## MEMORANDUM

**Date:** August 23, 2019 **File No.:** NB102-00181/53-A.01  
**Cont. No.:** VA19-01477

**Re:** **Mary River Project - Phase 2 Proposal - Revised Addendum to Technical Supporting Document 27 - Cumulative Effects Assessment**

Figure 1 Overview Map of Helicopter Flight Routes

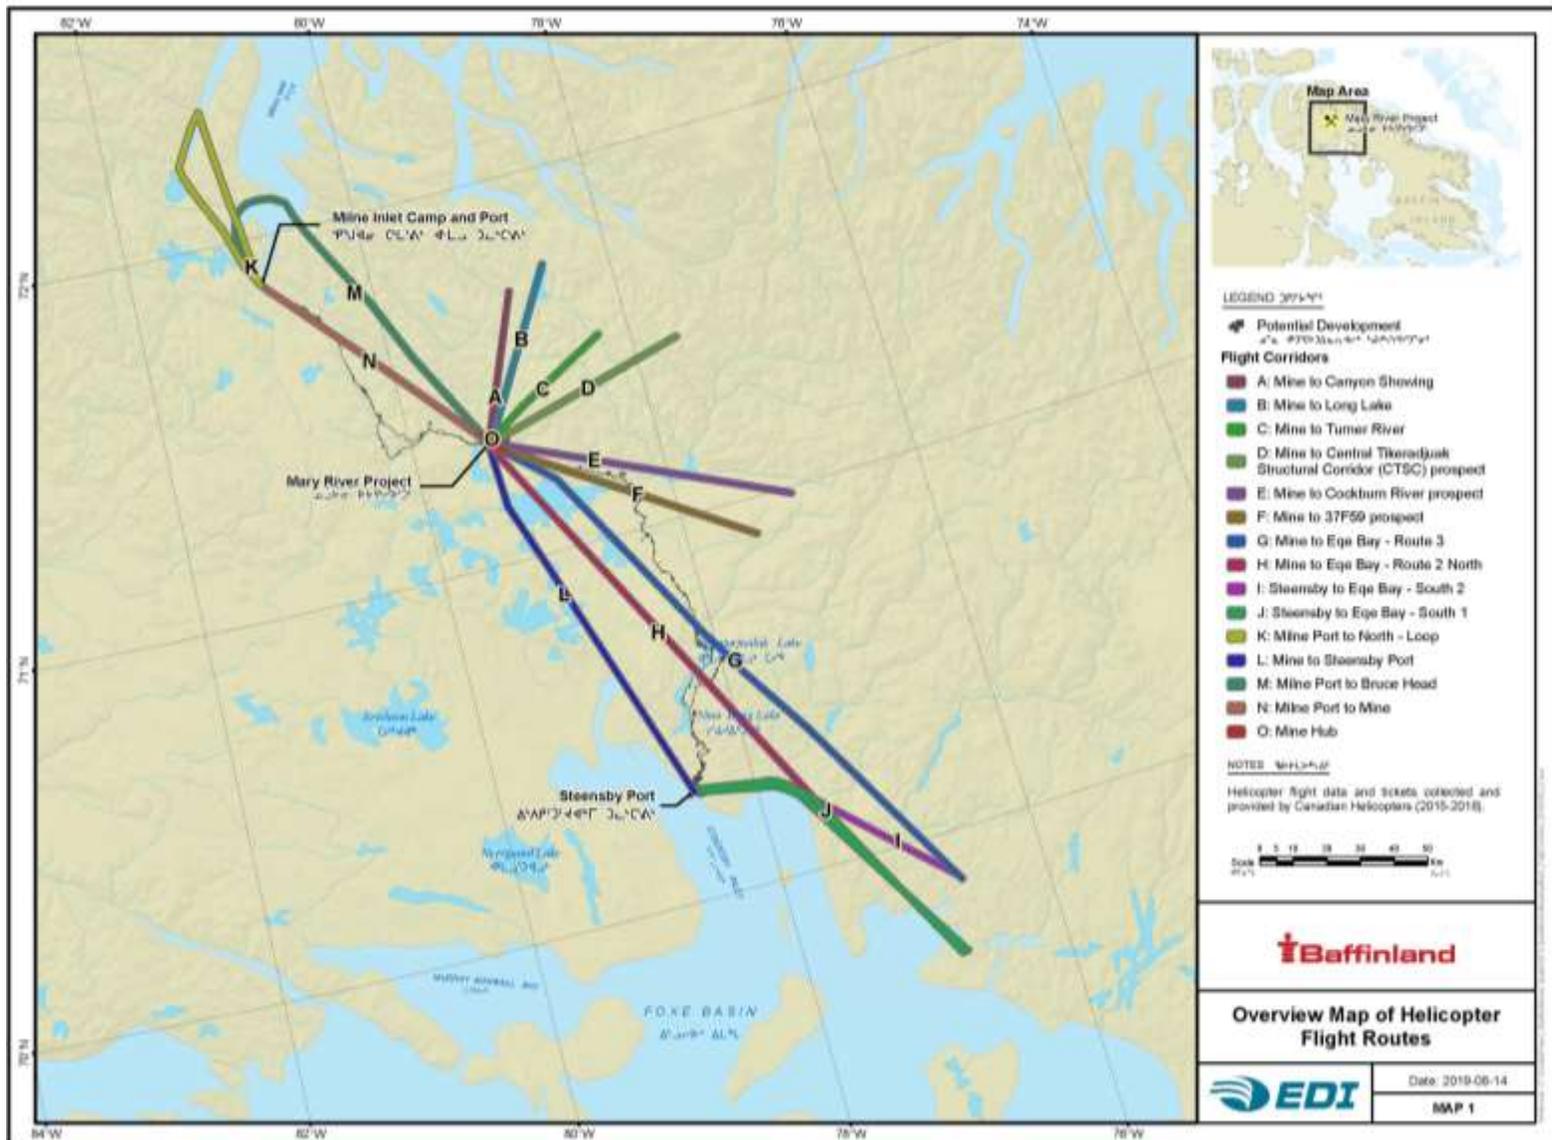
- **Additional Projects and Activities to Consider** - Include Baffinland-related helicopter overflights <300 metres above ground level (magl) located outside of existing ZOIs as existing disturbances with reasonable habitat disturbance coefficients; consider exploration activities at Deposits No. 6 to 11 as part of the future development scenario in the CEA.
- **Disturbance Coefficients** - Adjust the disturbance coefficients (DCs) assigned to the ports (Milne and Steensby) and municipalities.
- **Sensitivity Analysis** - Include a sensitivity analysis of cumulative impacts by providing under- and over-estimates of potential disturbance associated with anthropogenic disturbances.

In response, the Baffinland EIS team suggested that the extent of the ZOI along the transportation corridor should be reduced from 14 km to 4 km based on literature. The GN (S. Atkinson) preferred that the ZOI remain as is and the DCs be adjusted for the ports. They additionally asked that we apply a ZOI (S. Atkinson mentioned 1 or 2 km) and a DC (S. Atkinson mentioned "...certainly not a 95% reduction, but something") be applied to helicopter overflights as an existing disturbance.

Sixteen distinct helicopter flight corridors were identified by visually analyzing flight line data from 2015-2018. The frequency of use varies by year for many of the corridors (Figure 1). To determine what a ZOI may be for helicopter overflights, the centreline of the corridors was buffered by 1 km on each side (i.e., a total 2 km wide ZOI) to represent the potential ZOI of the most frequently used travel routes by helicopters in the project area. The 1 km buffer ZOI was selected as an area within which caribou may become disturbed by helicopters flying < 300 magl based on Miller and Gunn's (1979) landing distance of 1,000 m or more to avoid disturbance to caribou. The helicopter ZOI applies to areas outside of existing ZOIs previously identified for project effects assessment.

A caribou's potential exposure to helicopter overflights along the individual corridors varies considerably, from 0.01 (Corridor A) to 1.25 flights per day (Corridor M) depending on route and year (Table 1). No helicopters are present on the site during the winter, so no helicopter overflight disturbance occurs to winter habitat.

Figure 2 Mineral Leases and Claims in the Vicinity of the Project

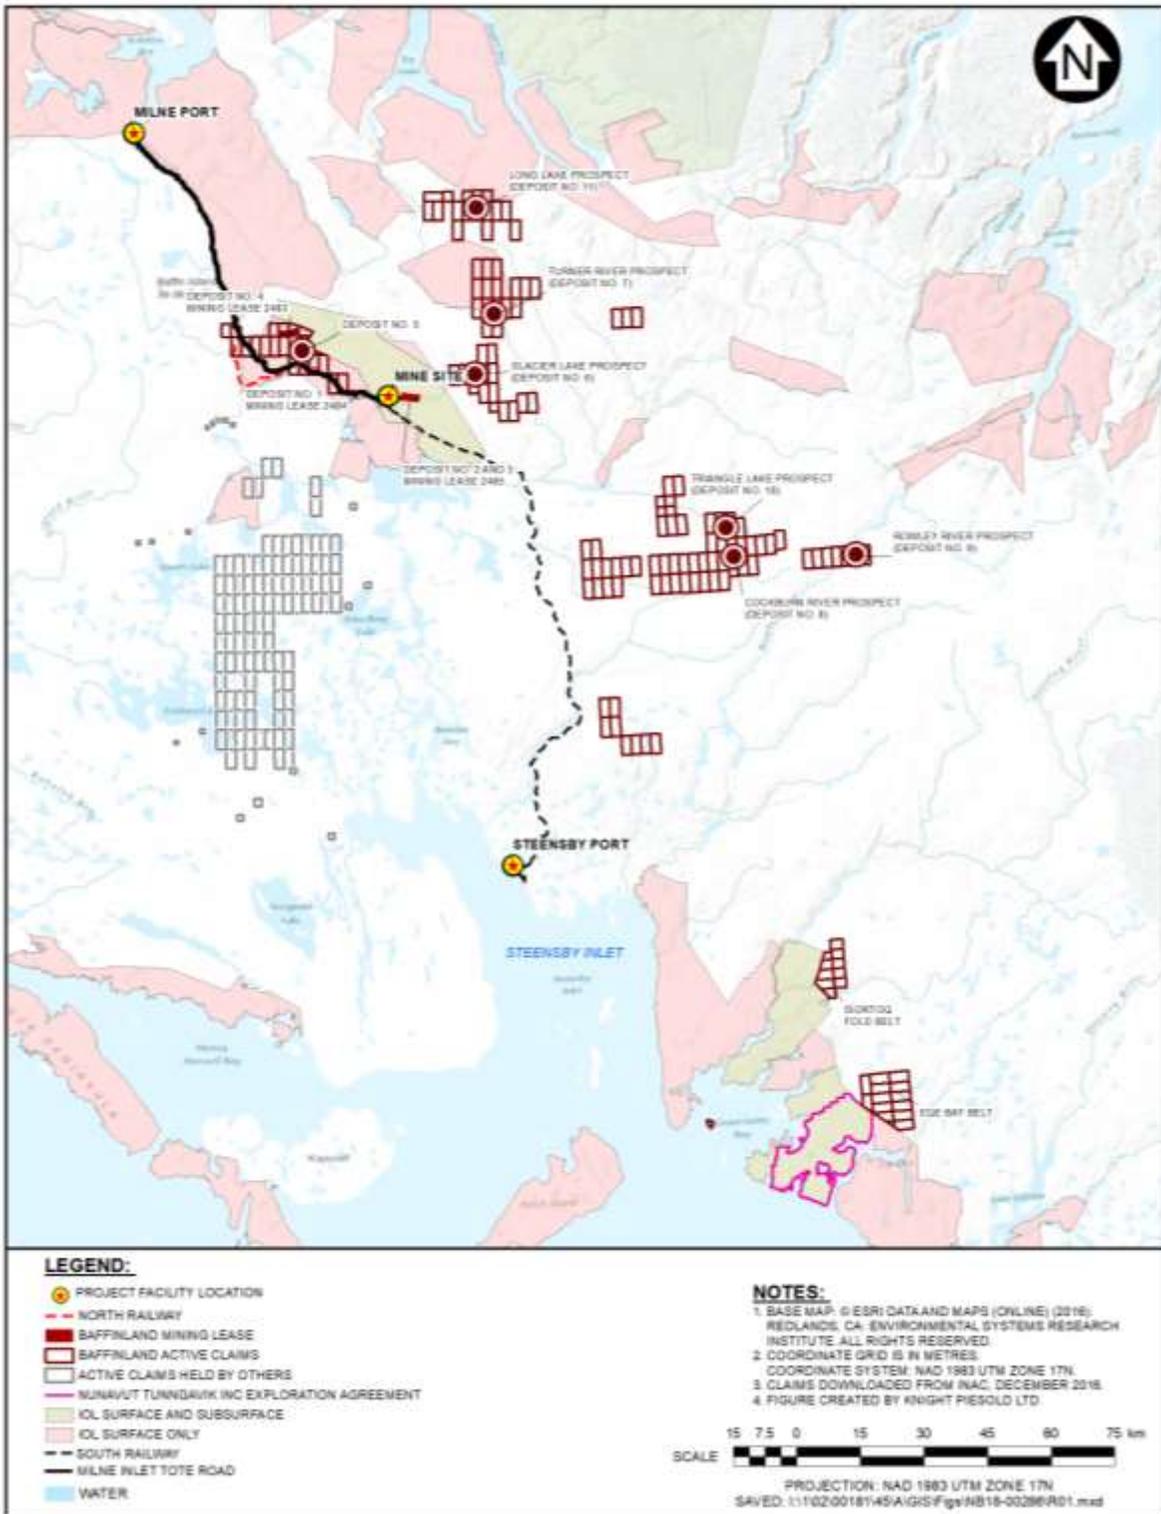
1. *The Proponent should update its CEA to include its plans for potential future development.*

The GN requested Baffinland to consider incorporating exploration of Deposits No. 6 to 11 into the future development scenario in the CEA. The future development scenario adopted by Baffinland ambitiously considers the exploration and development of all of four additional deposits (Deposits No. 2 to 5) within the temporal boundaries of the assessment. If this future development scenario was actually realized, it is unlikely that any exploration would occur on any of the other deposits (Deposits No. 6 to 11) over the temporal scale of this CEA. Thus, exploration of these additional deposits has not been considered.

Baffinland has identified 11 iron ore deposits to date (Figure 2). While surface exploration and in some cases limited drilling has identified several promising iron ore deposits, no other mineral resource estimates have been developed. Mineral resource estimates are required before engineering feasibility studies can be undertaken, and such feasibility studies would define the what, how and when in terms of a mine plan and transportation facilities. The EIS Guidelines clearly defines what a reasonably foreseeable project is, and Baffinland’s additional iron ore deposits do not meet any of the criteria.

Figure 4 Zones of Influence of Existing and Reasonably Foreseeable Disturbance in Caribou Habitat

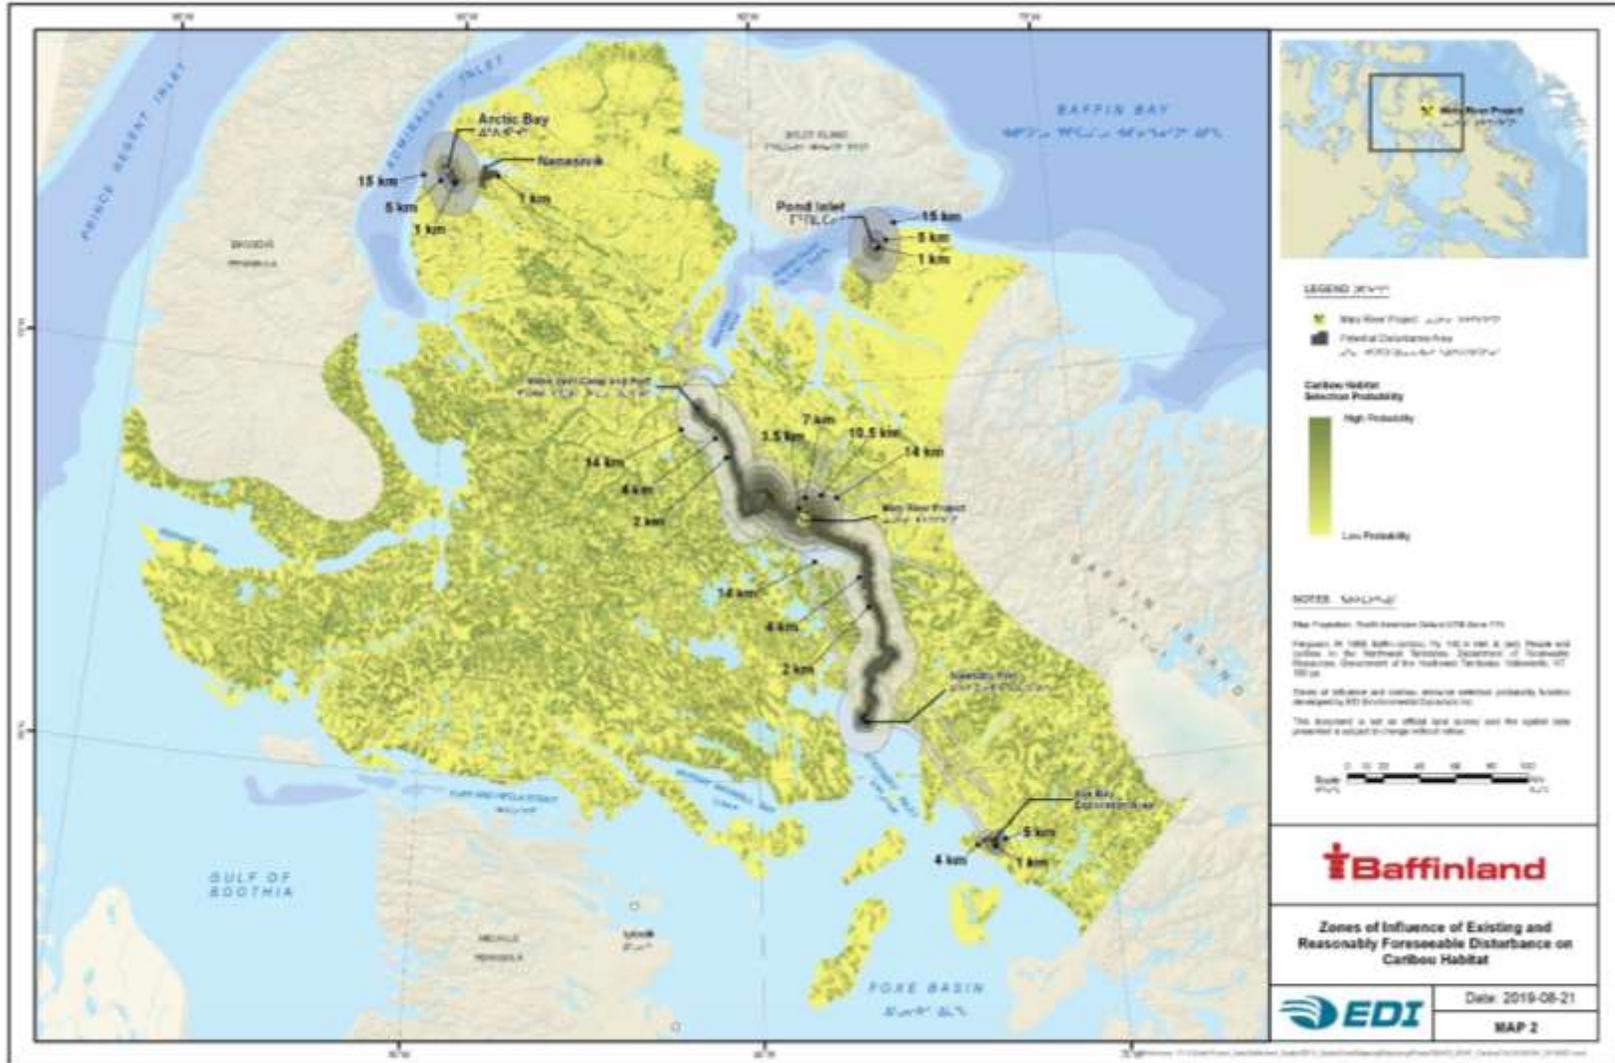
7. *The Proponent should provide maps and tables showing the sites and activities included in the existing and future CEA scenarios including the zone-of-influence for each site and activity that is used in the CEA analyses.*

- A ZOI layer was created in vector format based on the Project ZOI boundaries identified in Table 3 and for non-Project disturbances identified in Table 5 (Figure 4). Overlap in ZOIs was dealt with by the greatest DC superseding lower DCs (i.e., the greatest disturbance trumps the lower disturbance).

**Figure 5 Cruise Ship Activity in Nunavut (2010-2018)**

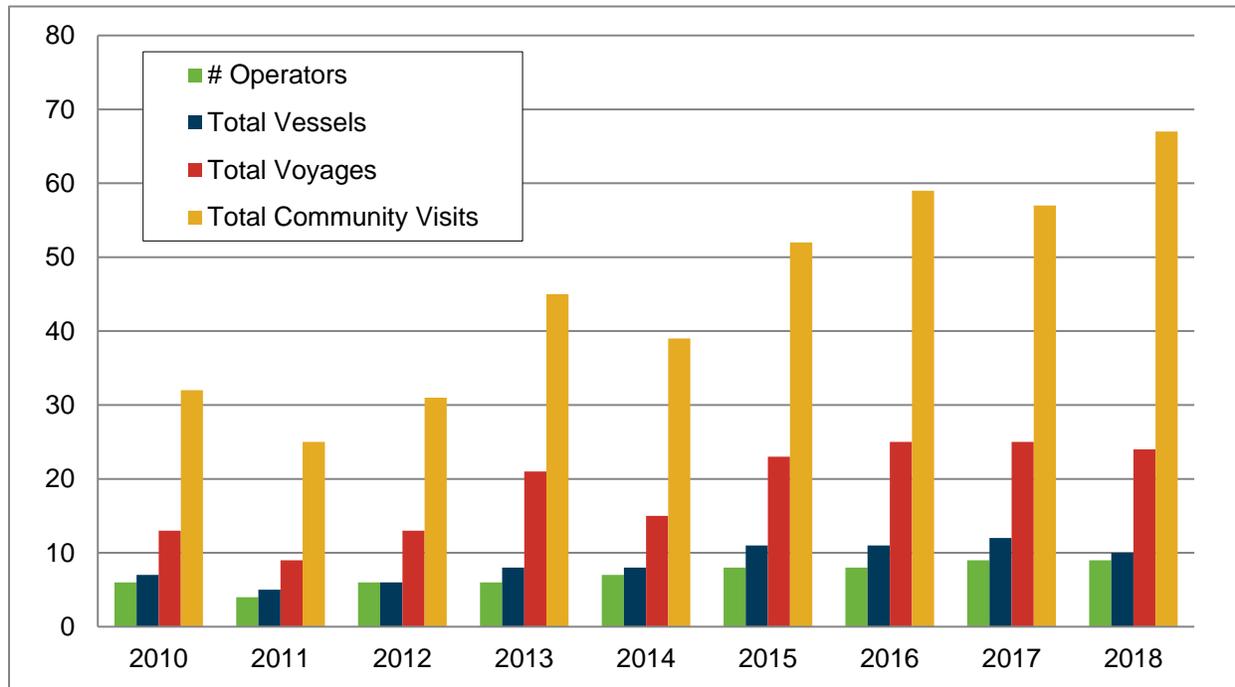
*Please describe shipping related effects of the Phase 2 Proposal, both cumulative and project related, in relation to effects to public/visitor safety and visitor experience (e.g.: quietness and solitude, experiencing marine mammals in a pristine environment), using:*

Trends in cruise ship activity visiting Nunavut communities from 2010 to 2018 is shown on Figure 5. Cruise ship activity from 2010 to 2018 at Nunavut communities increased from 32 to 68 community visits. The expected trend in 2019 is a similar or increased number of tourists visiting the area by cruise ships (Sebastian Charge, pers. comm.). The GN has noted that while cruise ship passenger numbers have been trending upwards over the past several years, that it is a very niche market and explosive growth is not expected (Nunavut News, 2018). Nunavut cruise ship traffic in 2018 consisted of 10 operators sailing 11 unique vessels that were expected to complete 24 voyages, with a total of 70 community visits planned to 13 communities including Clyde River and Pond Inlet (Nunavut News, 2018).
